"O" TIRES
 6985 MERIDIAN RD, PEYTON, CO 80831

SITE GRADING & EROSION CONTROL PLAN

PCD PROJECT NO. PPR-17-

Markup Summary

C1.1

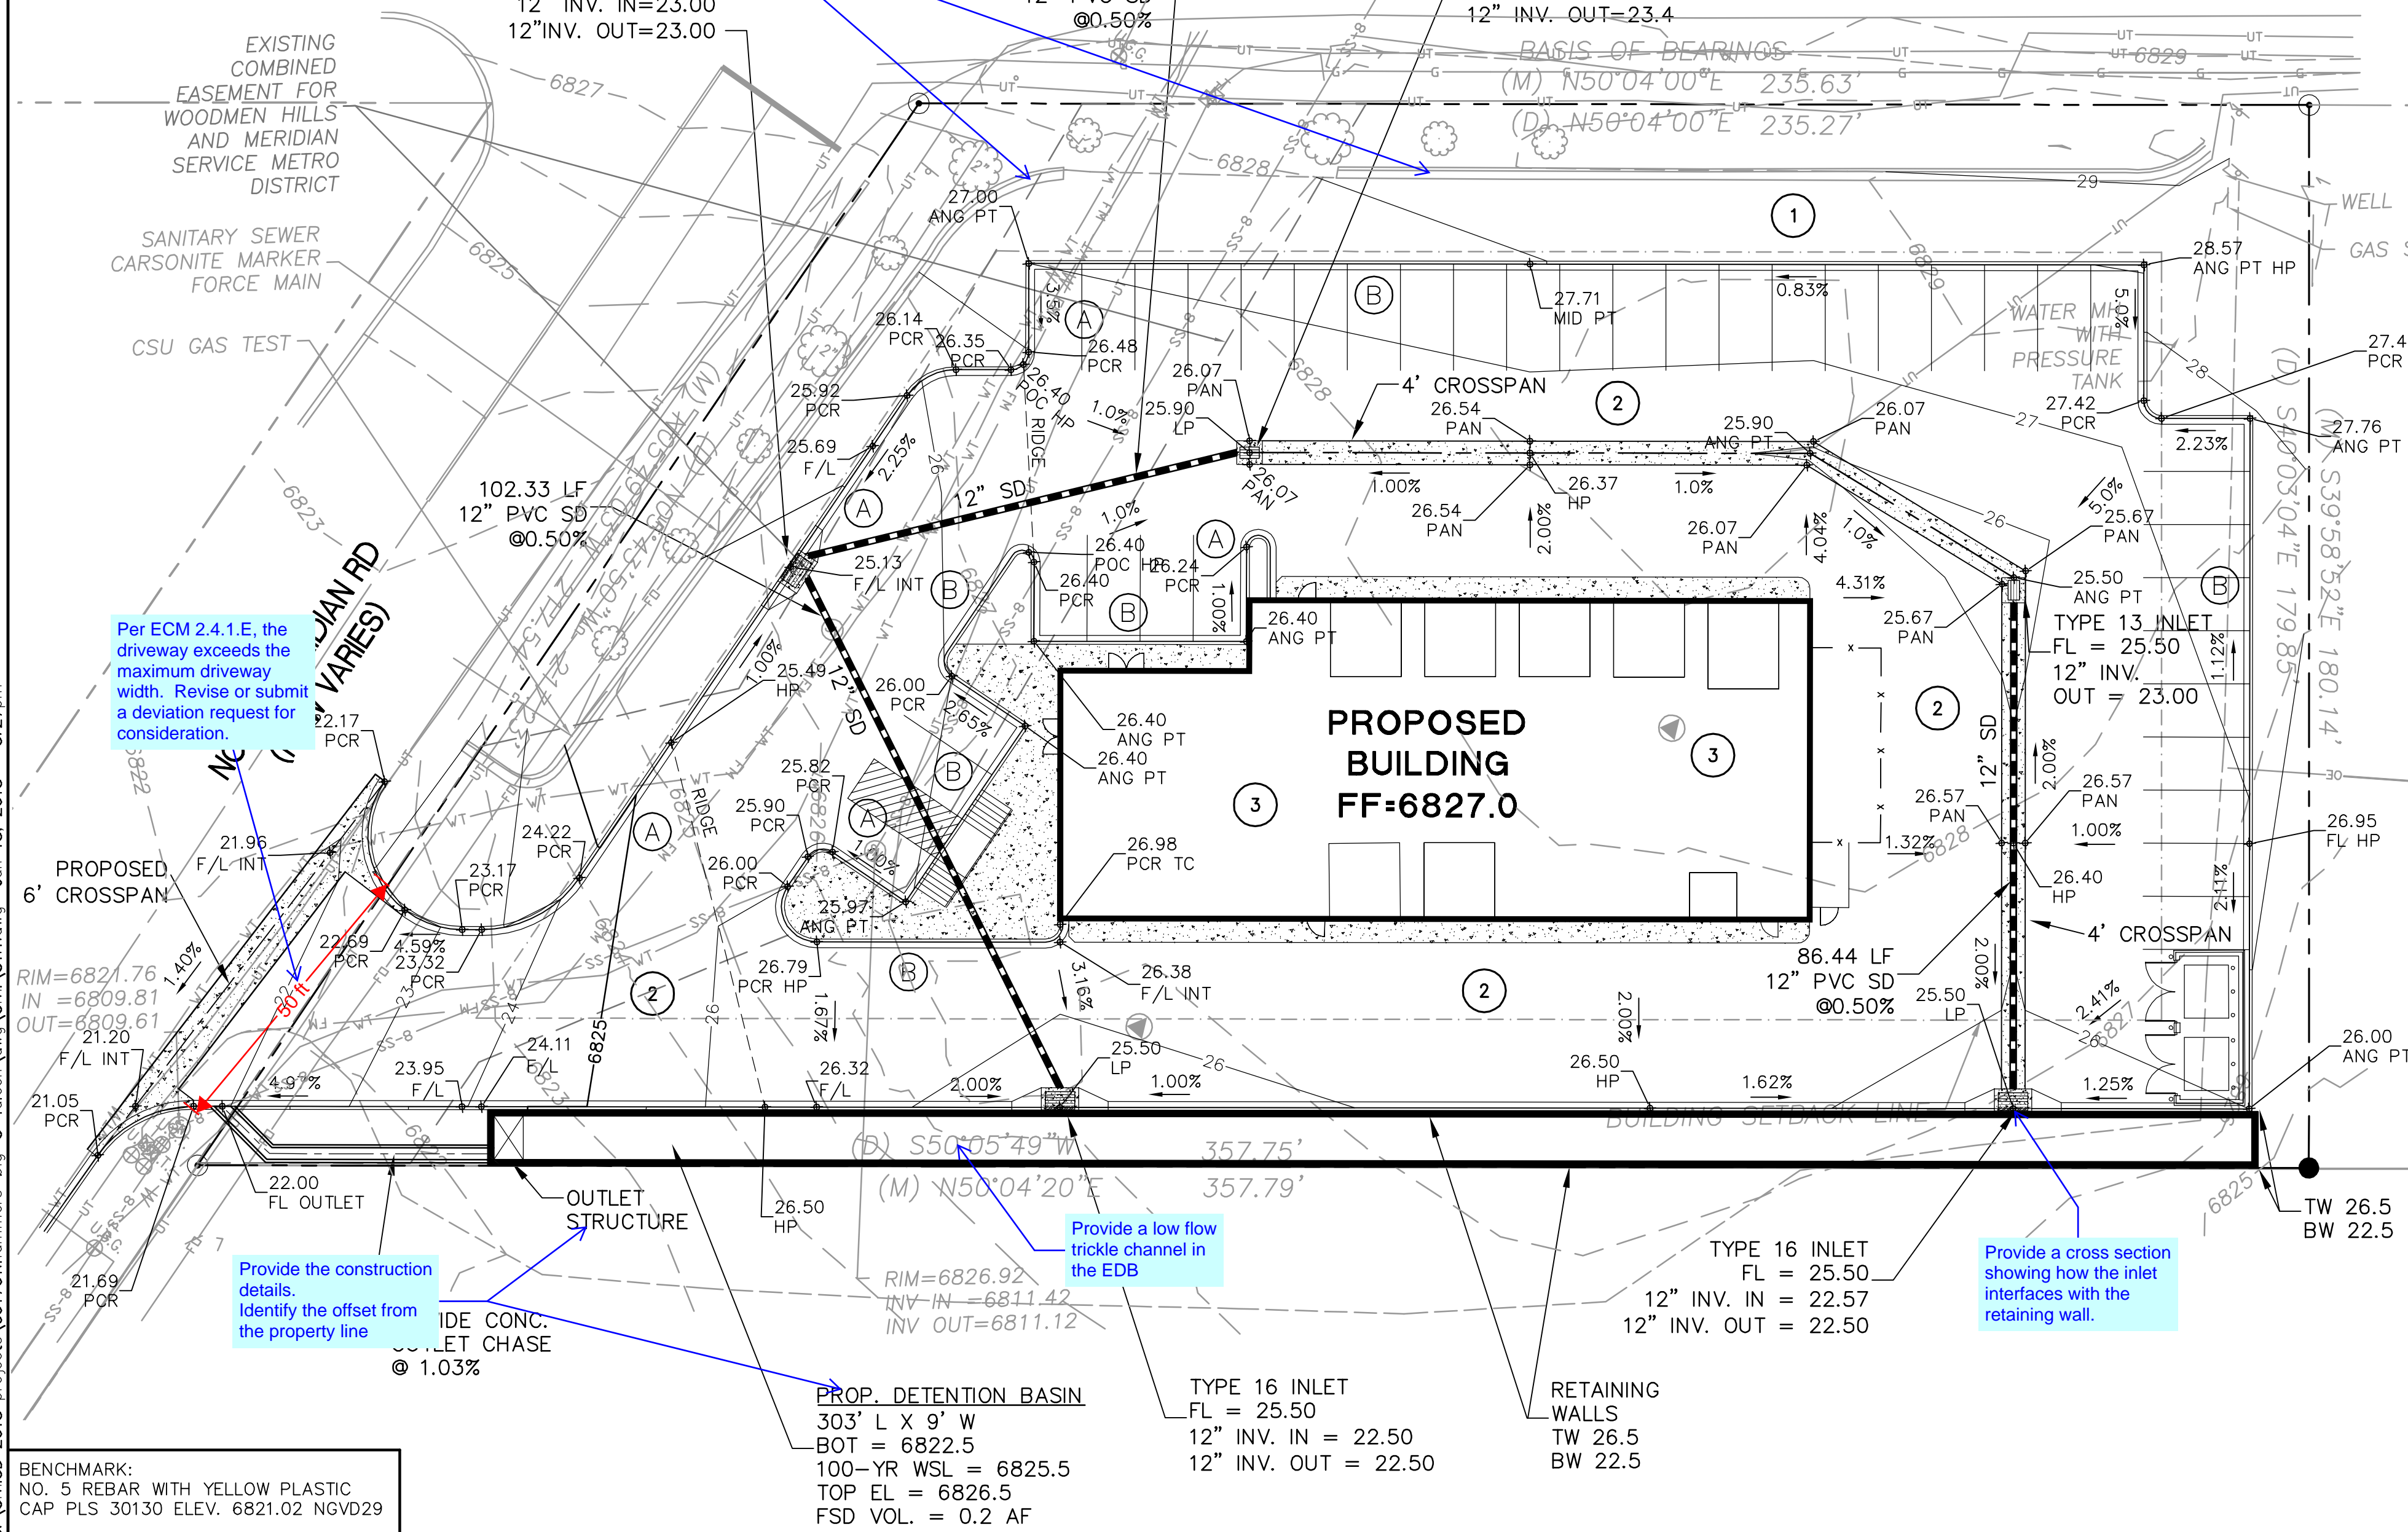
1. Add a cover sheet with sheet index & POC's.
2. Move the vicinity map and signature blocks to the cover sheet.
3. Include the EPC Standard Grading and Erosion Control Notes on the plan set.
4. Show the locations of the erosion control BMP's
5. Include details for the following:
 - temporary BMP's
 - Extended Detention Pond
 - EPC driveway cross pan
 - Internal cross pan.
 - Concrete outlet chase.
6. Per the SWMP, a temporary sediment basin will be installed in the interim. Therefore, show the temporary sediment basin, include the detail and provide the required volume and riser pipe configuration.

Provide a cross section showing how the inlet interfaces with the retaining wall.

Identify whether these are removed or protected in place

Per ECM 2.4.1.E, the driveway exceeds the maximum driveway width. Revise or submit a deviation request for consideration.

Provide the construction details.
 Identify the offset from the property line

Provide a low flow trickle channel in the EDB
